**CONSTRUCTION MANAGER
AT RISK SERVICES FOR
THE NEW FULTON
COUNTY ANIMAL
SHELTER FACILITY**

**#21RFP22421K-DB
11/18/2021**

**GUARANTEED
MAXIMUM
PRICE
PROPOSAL**

10/21/2021 GMP Impact Items - Narrative

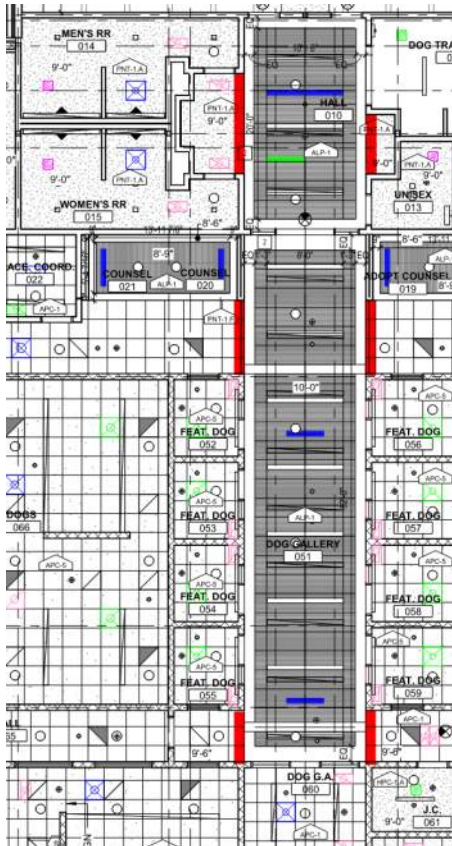
1. Color for PL-1 changed from Vapor Strandz 4939K-18 to Dove Geo Y0677-60 (2-4 week lead time)
2. Color for PL-2 changed from Washi Gold 5019-38 to White Cascade 5003-38
3. Color for SS-1 changed from Oatmeal 9101GS to Frosty White Mirage 1573MG
4. Dog Gallery and Hall 010 are open to structure. Areas highlighted in red to have drywall bulkhead to go up to deck to close off plenum space in this area.

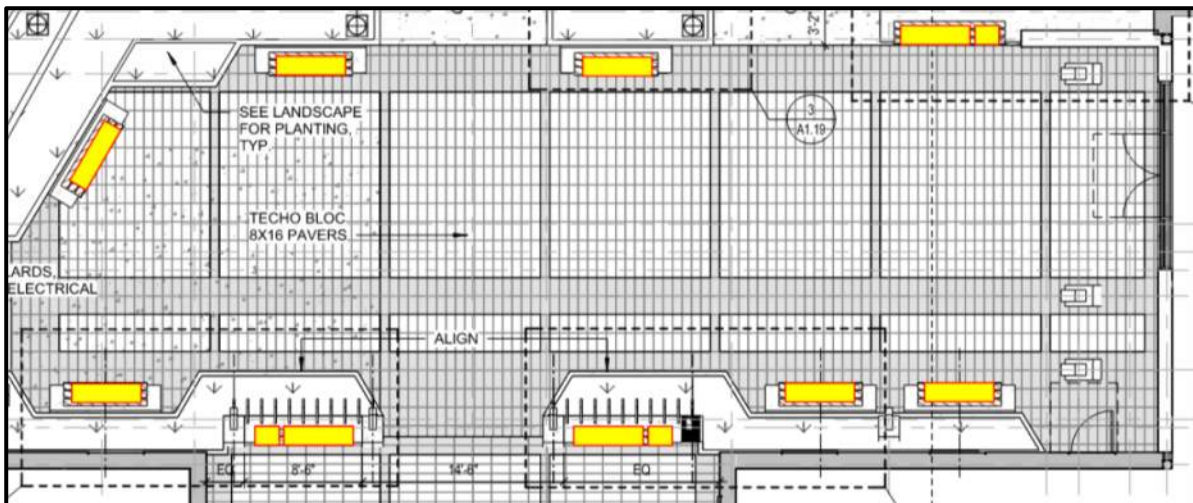
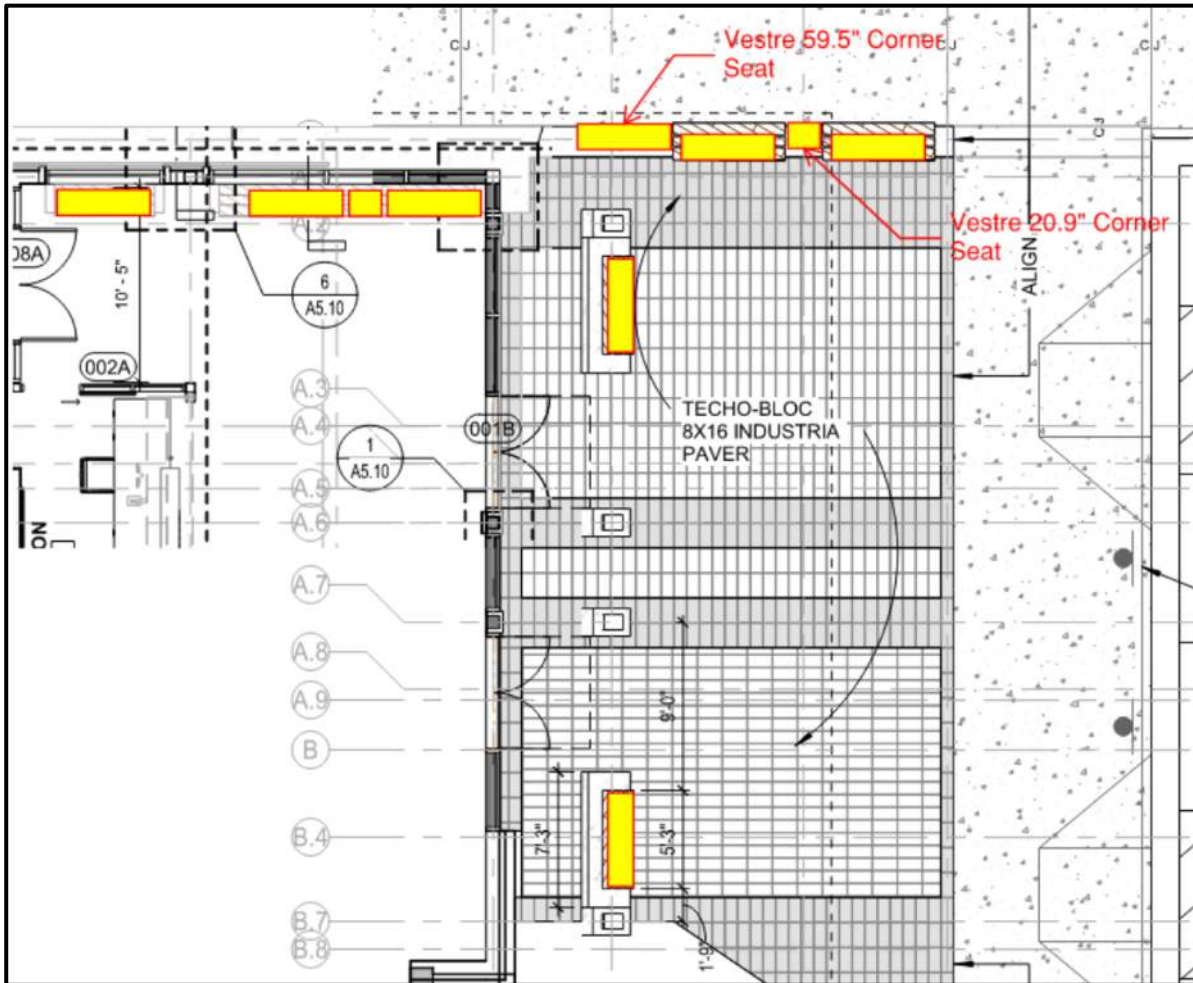
5. Sheet A4.11 shows Herringbone pattern tile in Single-Use Restrooms. This tile will be CWT-1 and will have 33% offset subway tile pattern (similar to elevations of restroom 049 and 050 on 3/A4.10).
6. Revisions to Equipment Schedule (per 10/18/21 meeting) – Revisions to be sent out on 10/22/21

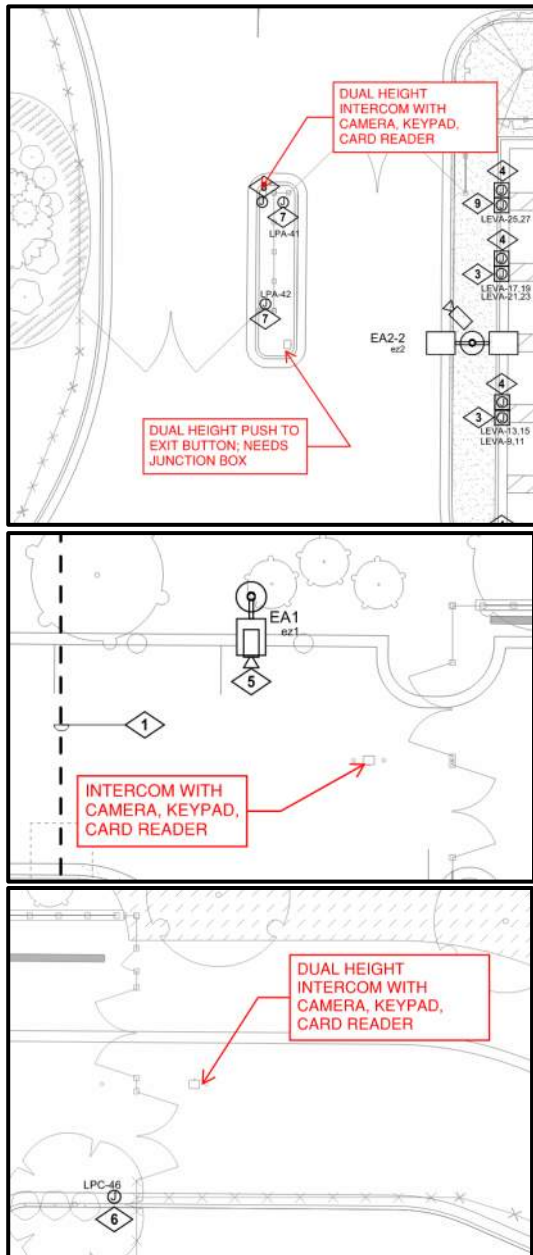
- 9. 022 Placement Coordinator Door to be Wood Door with HM Frame and moved for better privacy

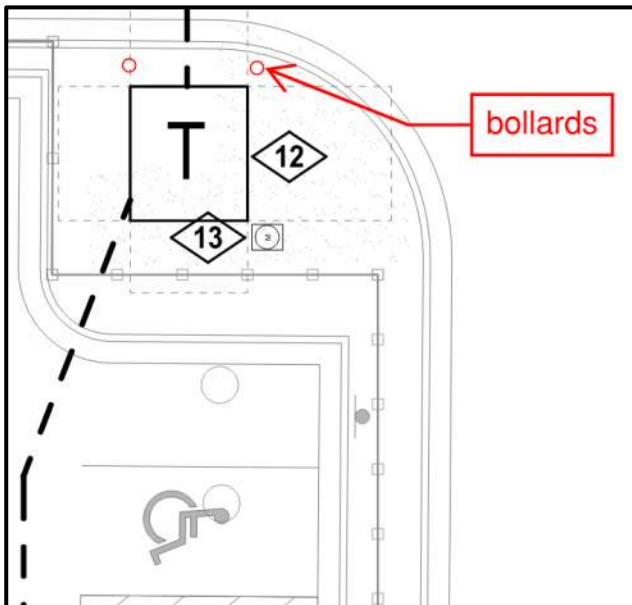
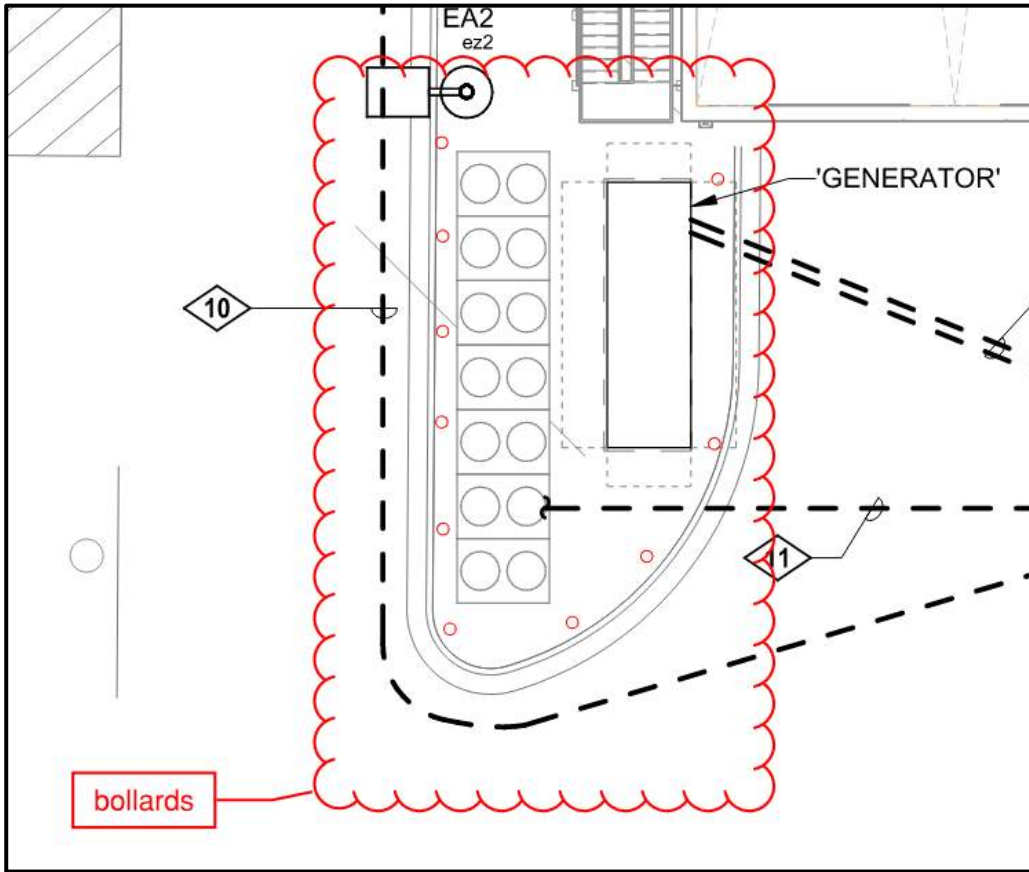
- 10. Call boxes, keypads, card readers at gated entries to be added

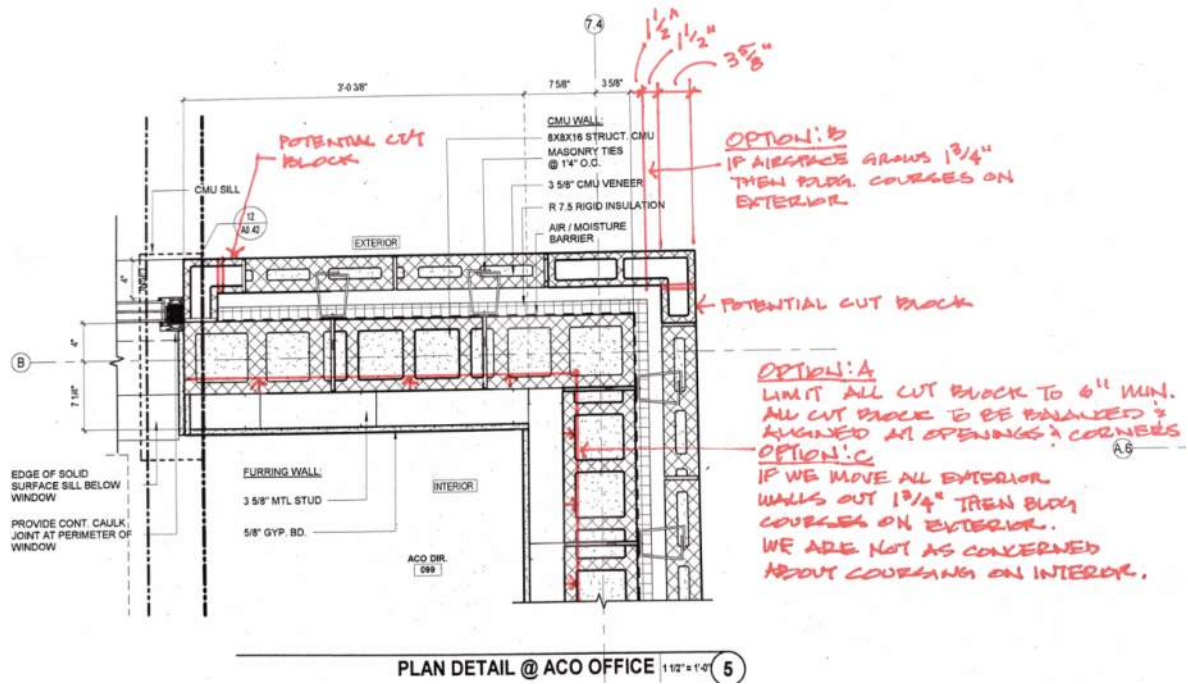
11. Bollards around exterior equipment to be added

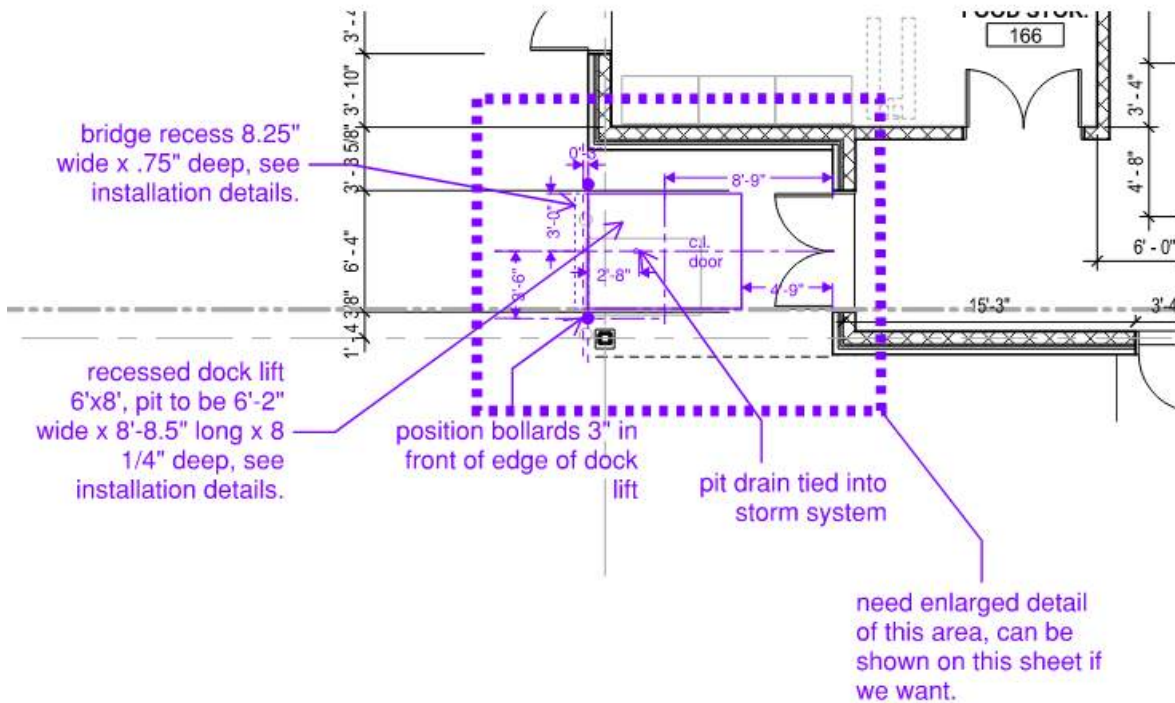
- 12. CMU veneer coursing to be studied (larger air gap vs expanding building to work with exterior coursing) – GC to contact mason.

10/25/2021 GMP Impact Items - Narrative

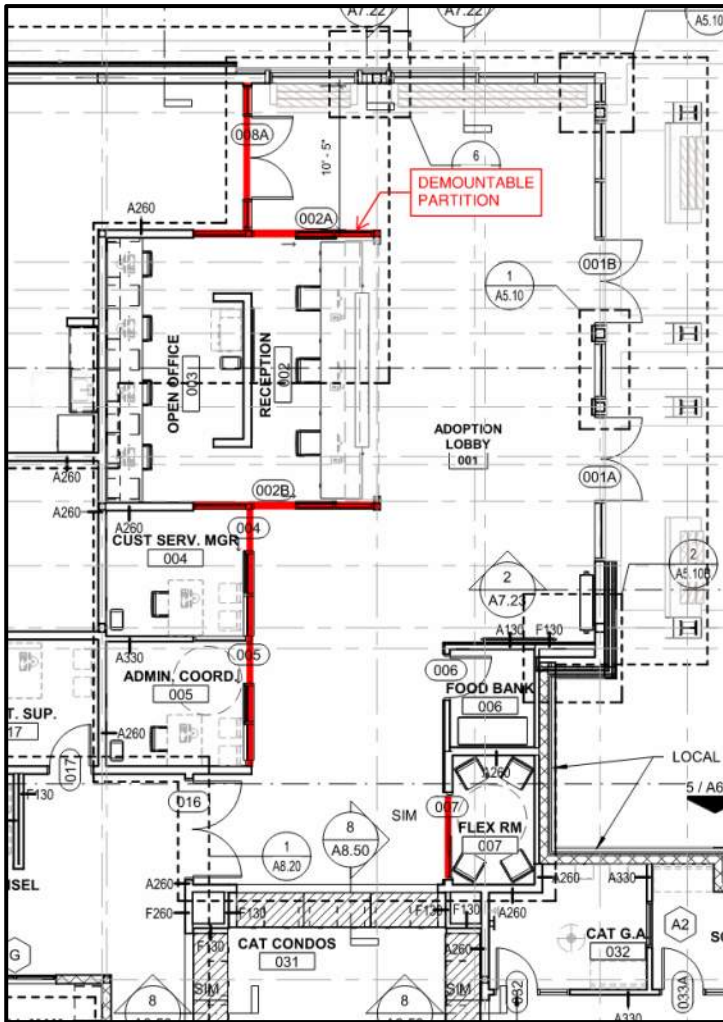
- 17. Walk Off Mats to be added to meet LEED Requirements (see attached diagram for locations)
- 18. Exterior Signage to be added at Intake Lobby/Clinic area. Will not need power
- 19. No Smoking Sign at all entries per attached diagram
- 20. Demountable Partitions at lobby to be priced out. Will be sent to GC week of 10/25.

SHEET NUMBER
A1.10

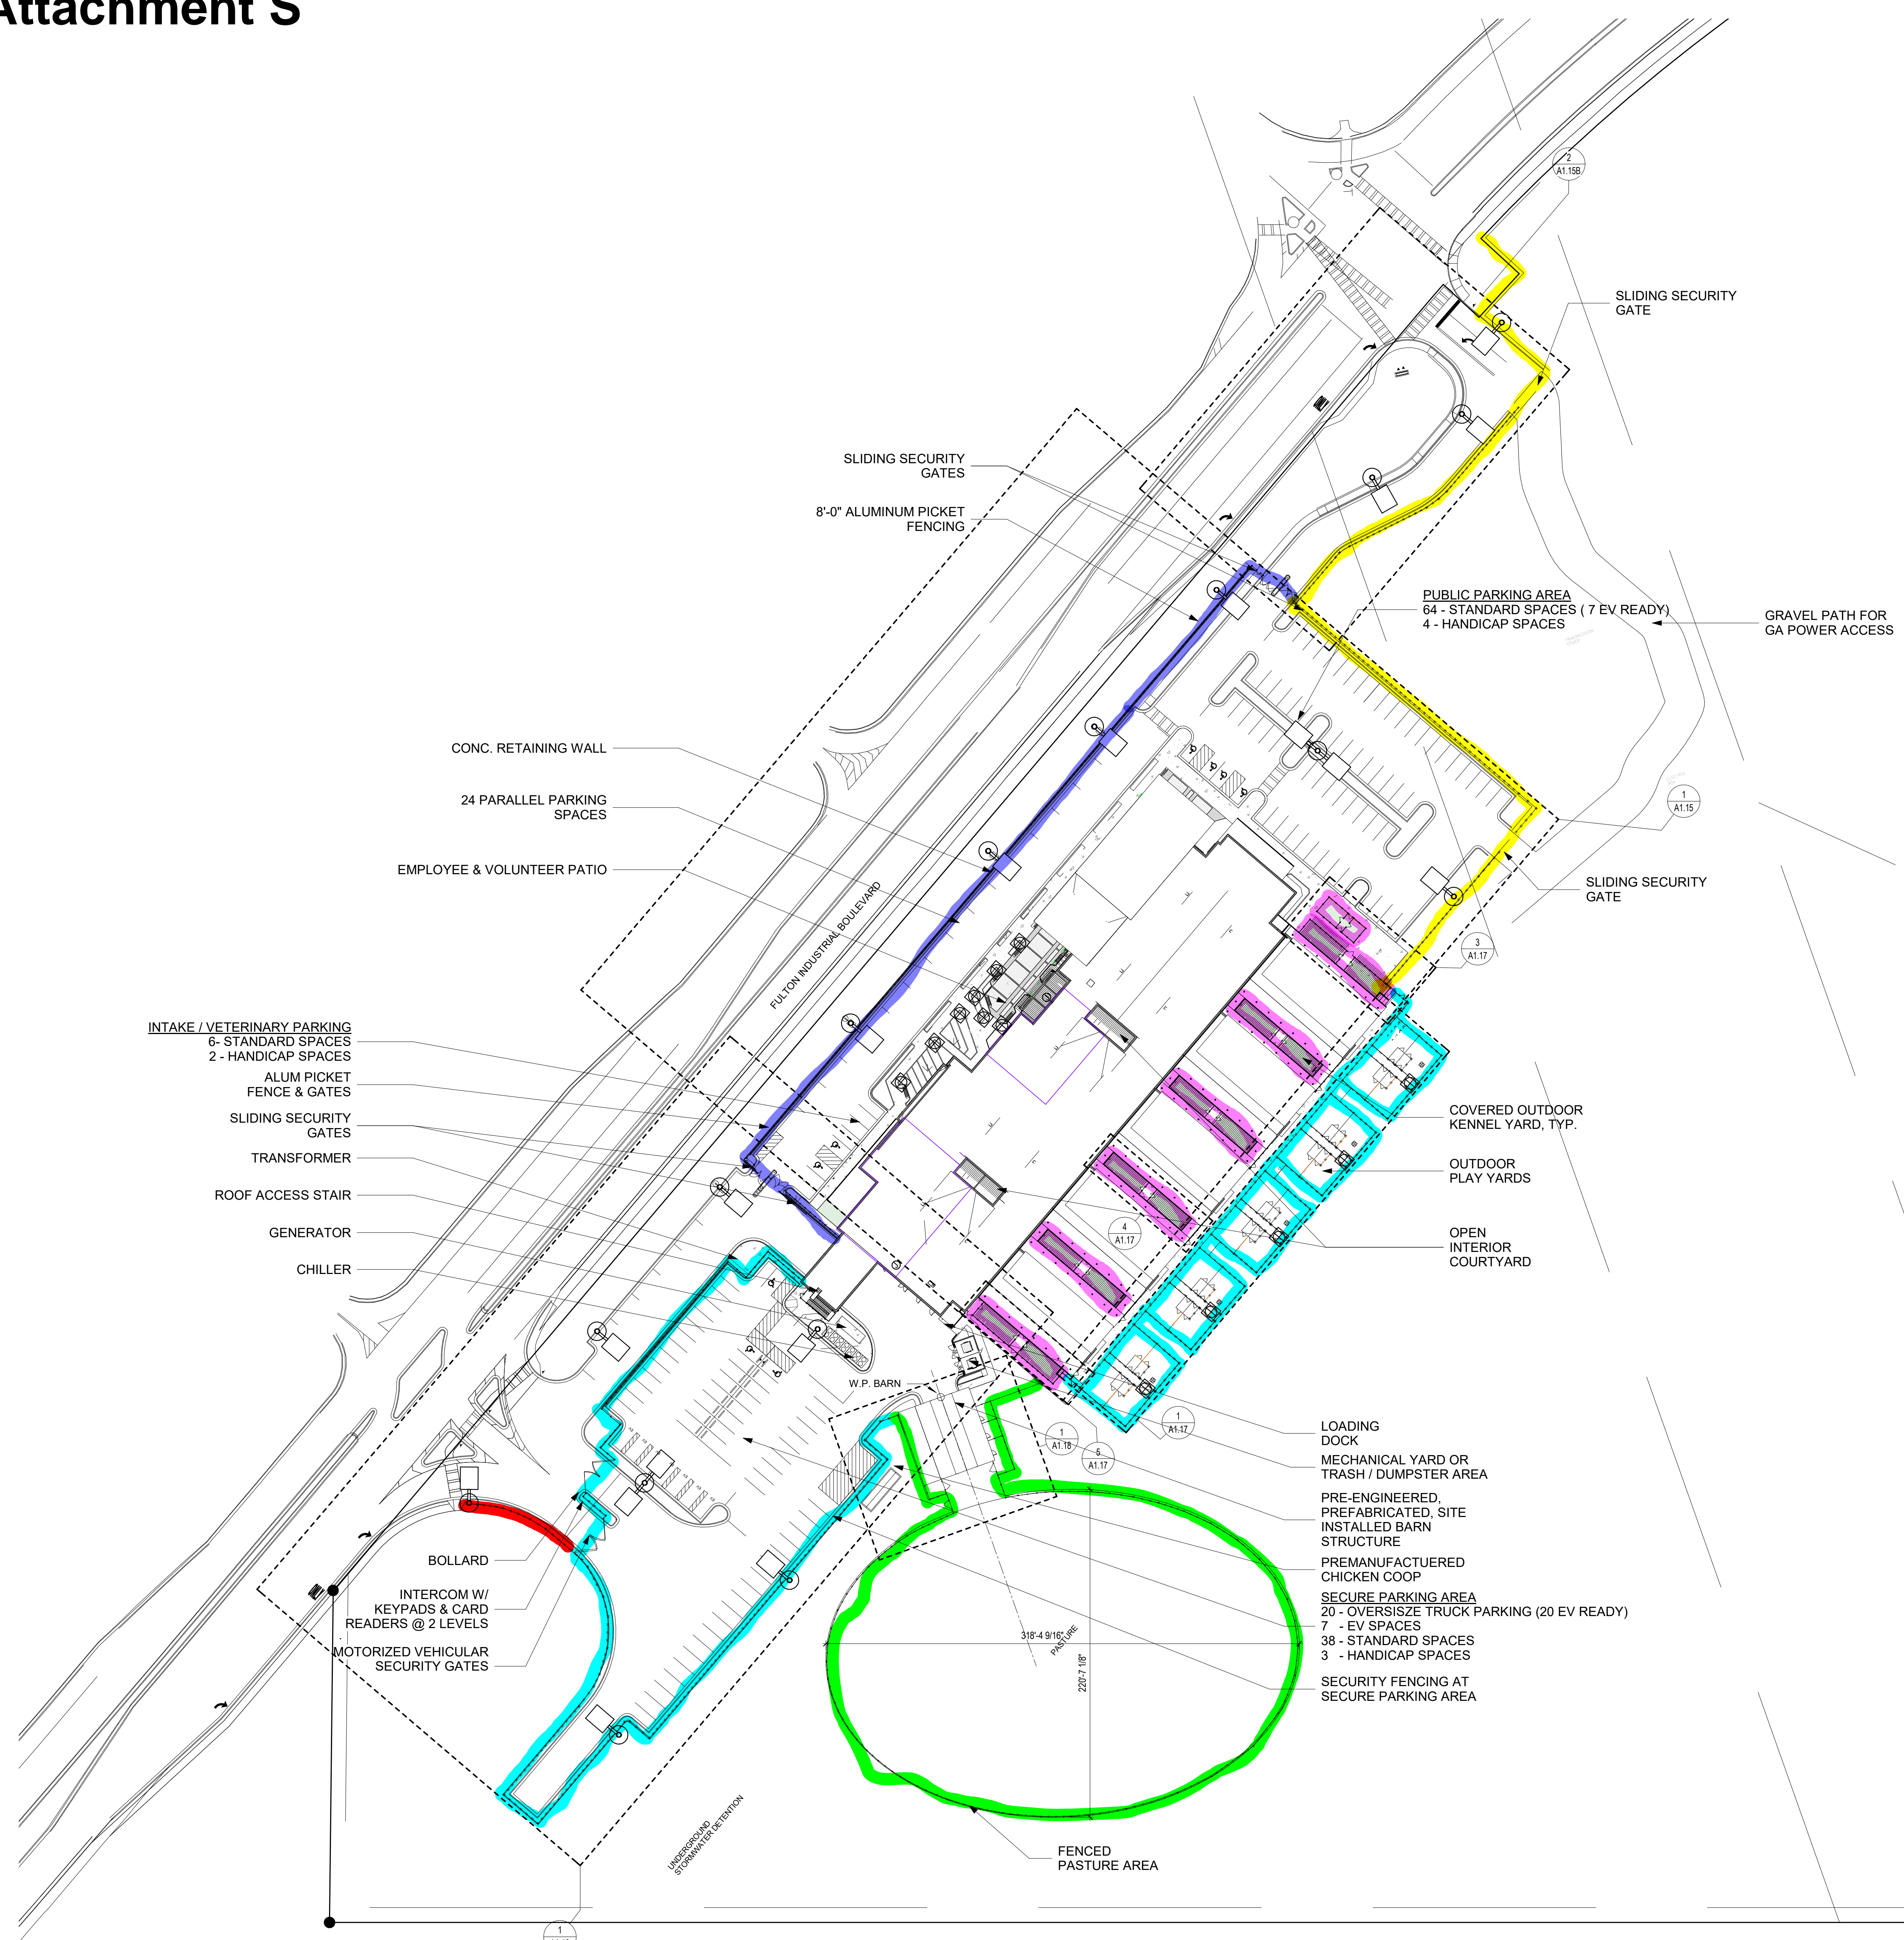
| RFI # | Date Issued | Drawing/Spec Reference | Description - RFI (by WJG u.n.o.) | Response Date | Description - RESPONSE (by PGAL u.n.o.) |
|-------|-------------|------------------------------|---|---------------|---|
| 1.13 | " | A1.10 | This sheets shows a gravel path for Ga Power access. Keynote 30 on C3.02 calls this out as a dirt path. Please clarify. | | Civil is correct, Architectural will revise note. |
| 1.14 | " | A1.10 | Please confirm that the EV ready spaces for the employee parking lot are correctly identified per sheet E1.03. | | Confirmed. 7 standard EV-ready spaces in parking lot. 20 oversized EV-ready spaces along drive. |
| 1.15 | " | A1.10 | The note for the public parking area calls for 7 EV ready spaces. Sheet E1.02 has circuiting for 5 spaces identified. Please clarify. | | E1.02 is correct, architectural will revise. |
